REMARKS

Please approve the drawing changes as shown in red in the attached marked-up copies of Figs. 1 and 6-7. A separate Letter to the Draftsman indicating the same proposed drawing changes is enclosed herein.

FIG.1

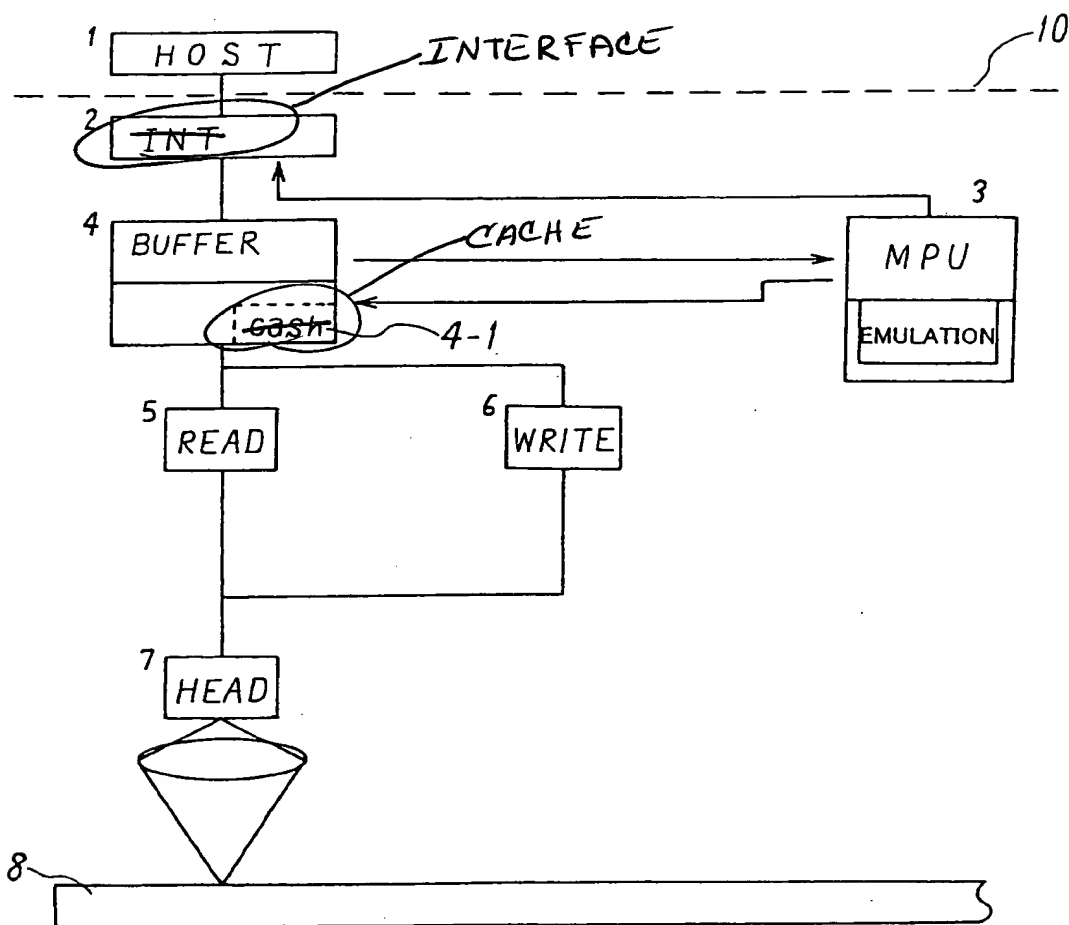
As a second preliminary matter, Figs. 1 and 6-7 stand objected to for informalities. Accordingly, Applicants have included herewith marked-up copies of these drawings, with the proposed changes shown in red. As can be seen from the proposed changes, Applicants have corrected the typographical errors noted in Figs. 1 and 6. Applicants have also rewritten the full text description of element number 2 in Fig. 1 from its abbreviated form, although Applicants submit that the original form was proper and clear.
